# UNITED STATES PATENT AND TRADEMARK OFFICE

APPLICATION NO.	FILING DATE	FIRST NAMED INVENTOR	ATTORNEY DOCKET NO.	CONFIRMATION NO.
10/687,481	10/15/2003	Yu-Jiun Wang		8931

<b>Office Action Summary</b>	<b>Application No.</b> 10/687,481	<b>Applicant(s)</b> WANG ET AL.	
	<b>Examiner</b> Timothy M. Ayres	<b>Art Unit</b> 3637

### **DETAILED ACTION**

Klakovich ('768) Fig. 7

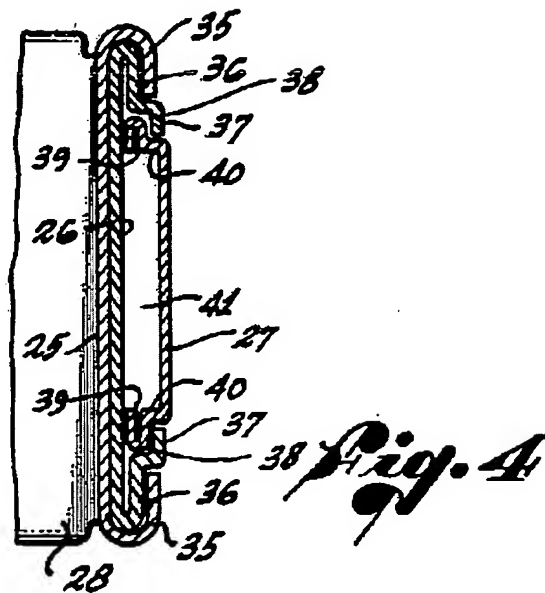
5. Claims 1-3, 5-11, and 13-16 are rejected under 35 U.S.C. 102(b) as being clearly anticipated by U.S. Patent 3,133,768 to Klakovich. Klakovich ('768) discloses a rail assembly (22) used to support electronic components. A rail bracket (25, 29) is fixed to a sidewall of a cabinet. An outer rail (26) is movable to the rail bracket (25, 29). An inner rail (27) is movably received in the Outer rail (26). A blocking member (53) on the outer rail (26) and engages with an acting member (52) to cause concurrent movement of the inner rail (27) and the outer rail (26) (Col. 4, line 3-14; Col.3, line 51-62).

The inner rail (27) has flanges (39) that fit into guiding portions (38), which are created on the outer rail (26) with lip (37). Railings (36) of the outer rail (26) slide in guiding portion (35) of the rail bracket (25). The inner rail (27) and the outer rail (26) have base plates that are the straight portions defined on both sides of the gap (41).

Klakovich ('768) Fig. 4

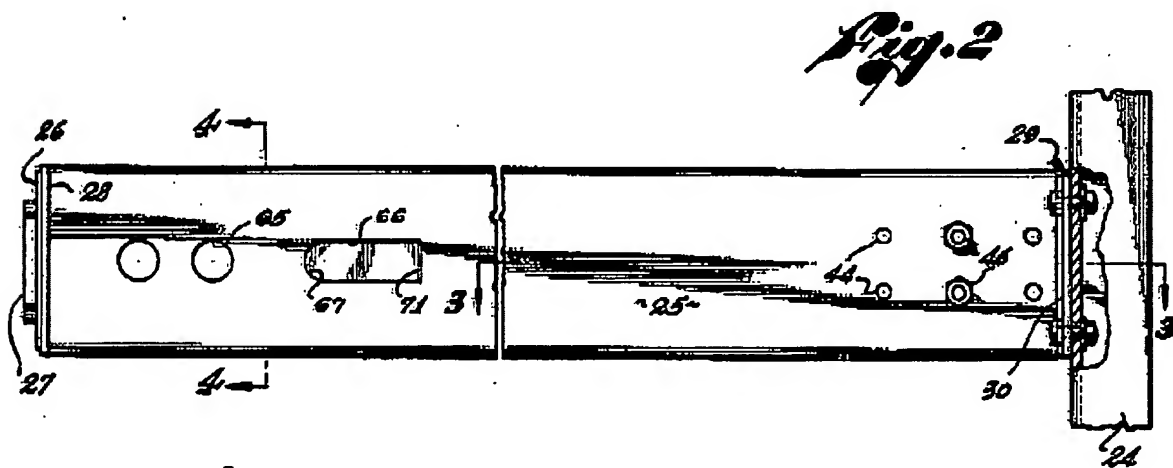
The rail bracket assembly includes a first part (25) that includes an adjustable bracket (29) that mounts to a cabinet. The bracket (29) is adjustably connected with multiple holes (44) and bolts (46) to the first part (25).

Klakovich ('768) Fig. 2

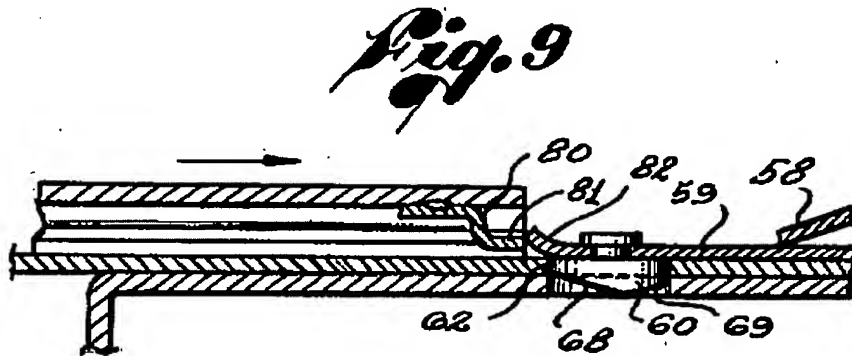
The rail assembly includes plate (59) attached to outer rail (26), which abuts to the tab (81) that is attached on inner rail (27) and prevent movement between the inner rail (27) and the outer rail (26).
